Certificate of Appropriateness

2009 S. 19TH ST.

Christ Polish Baptist Church

PTS ID 114592 COA: wheelchair ramp and new door

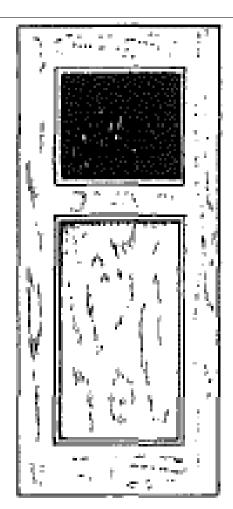
This is the ideal door for the rear, without glazing. A similar two-panel design with taller bottom panel should be the goal.

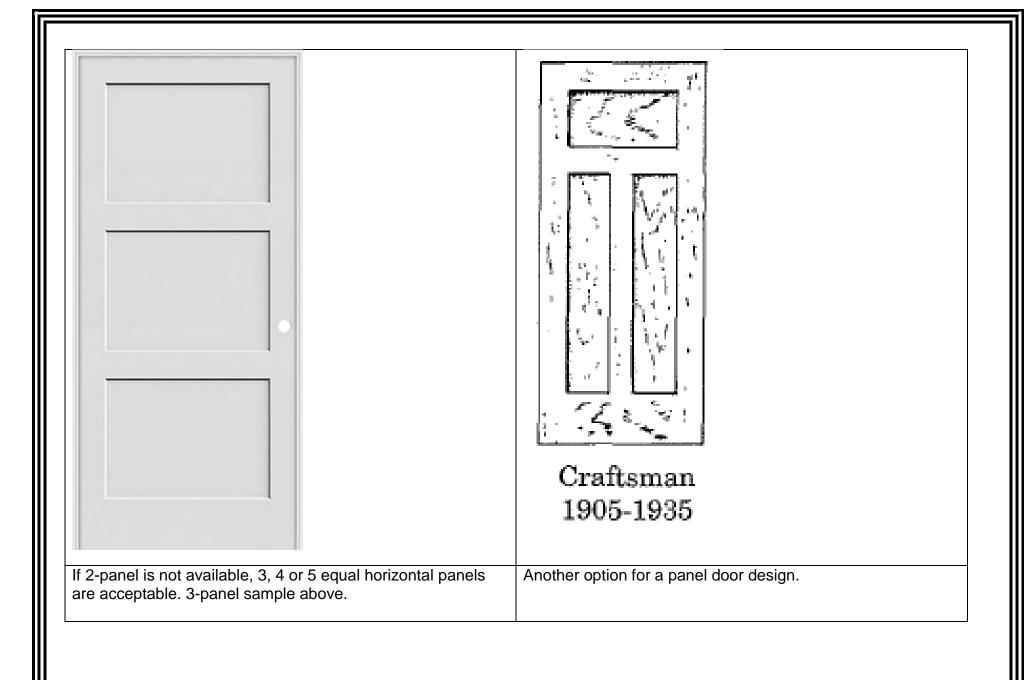
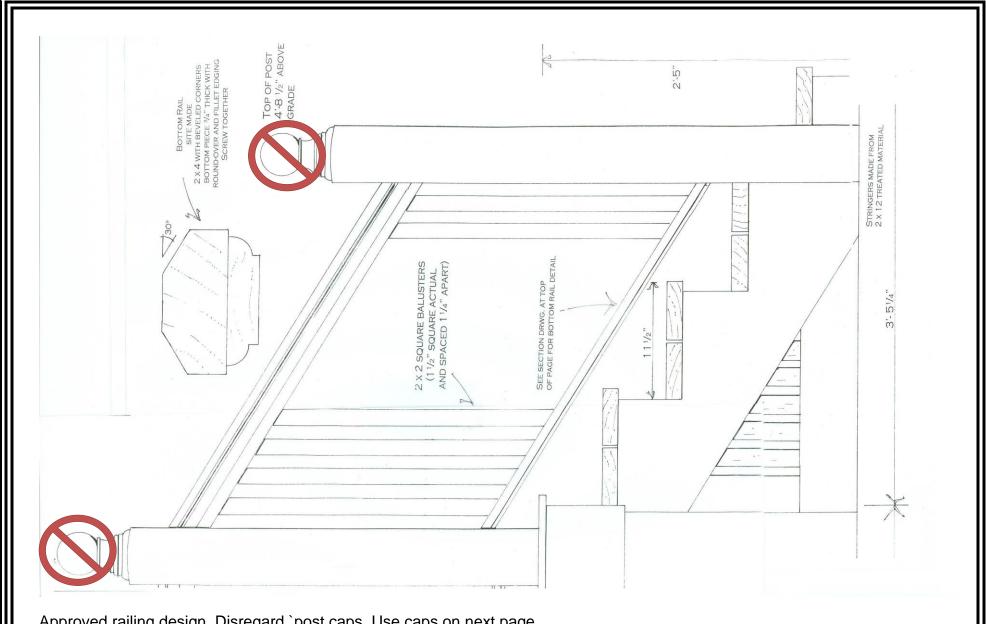
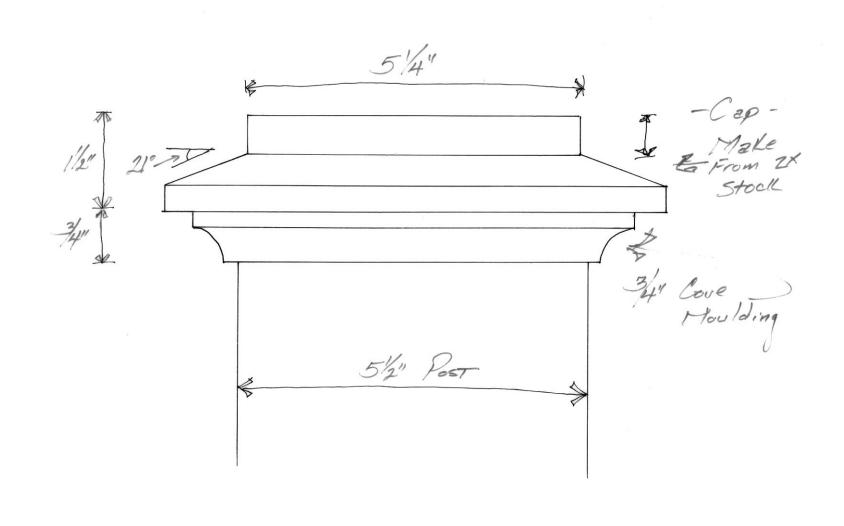
Schematic design for door at left. Again, without glazing.

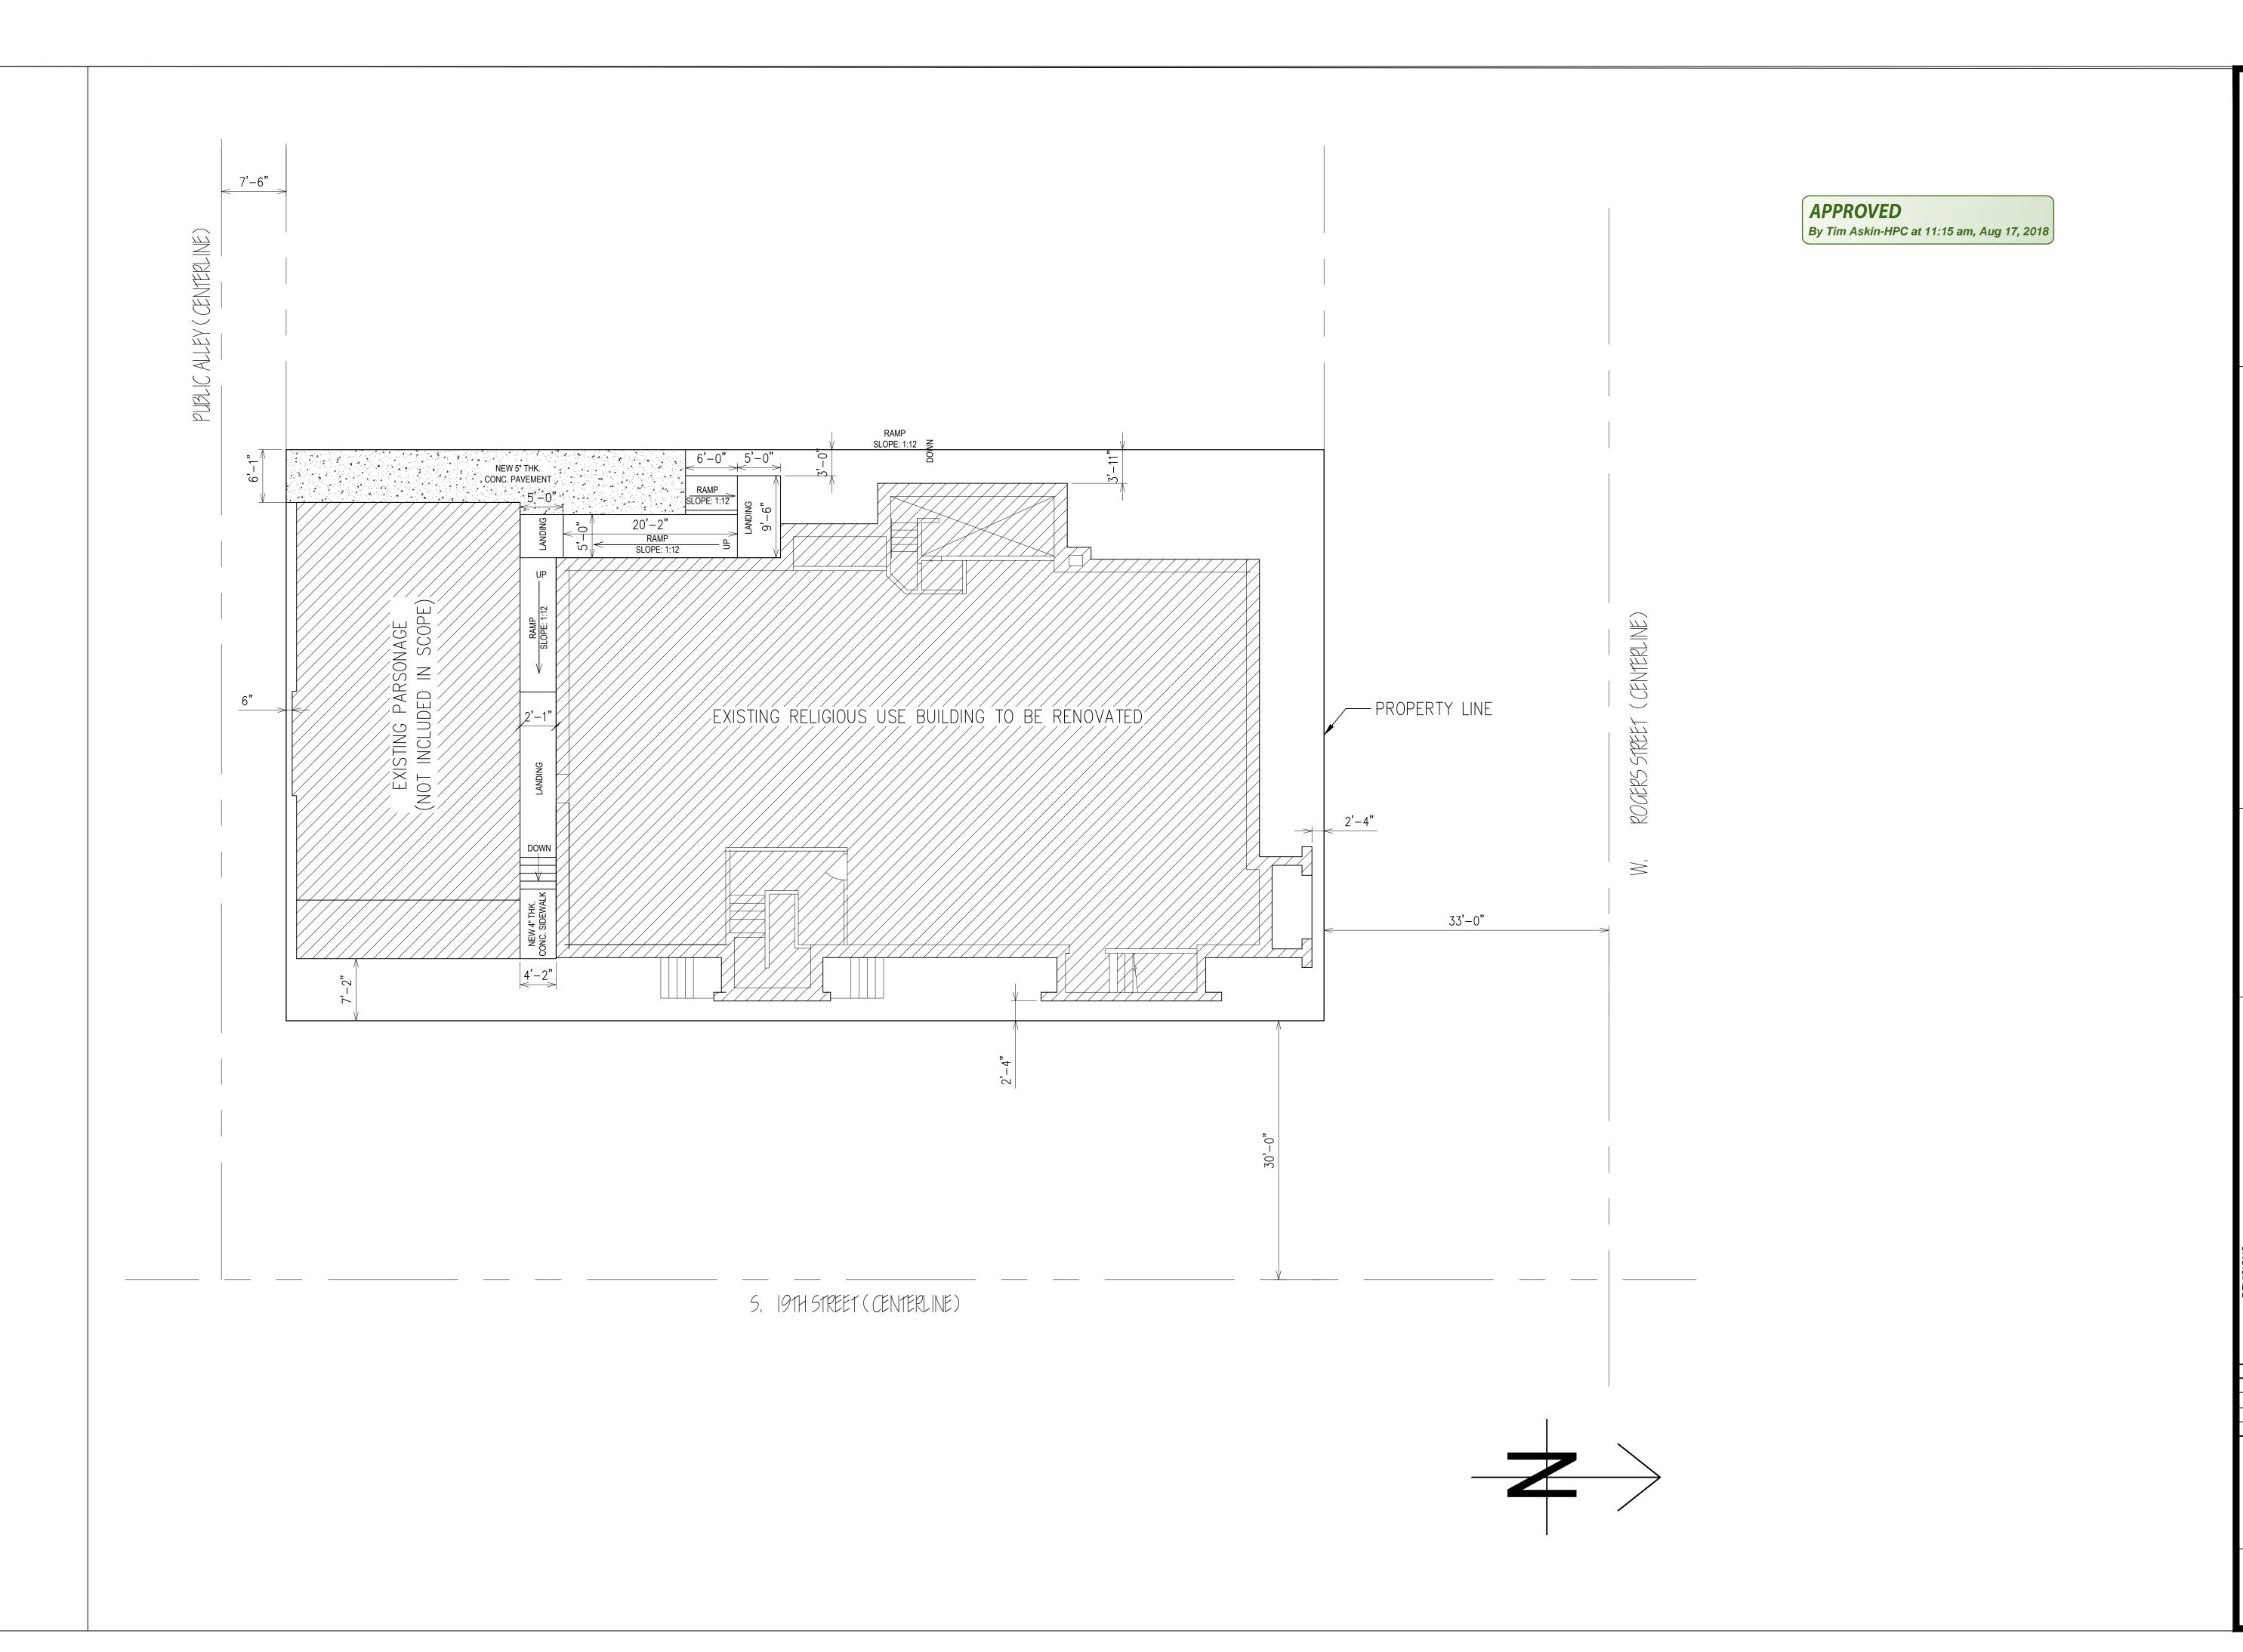
Use this post cap detail instead of ball design on previous page.
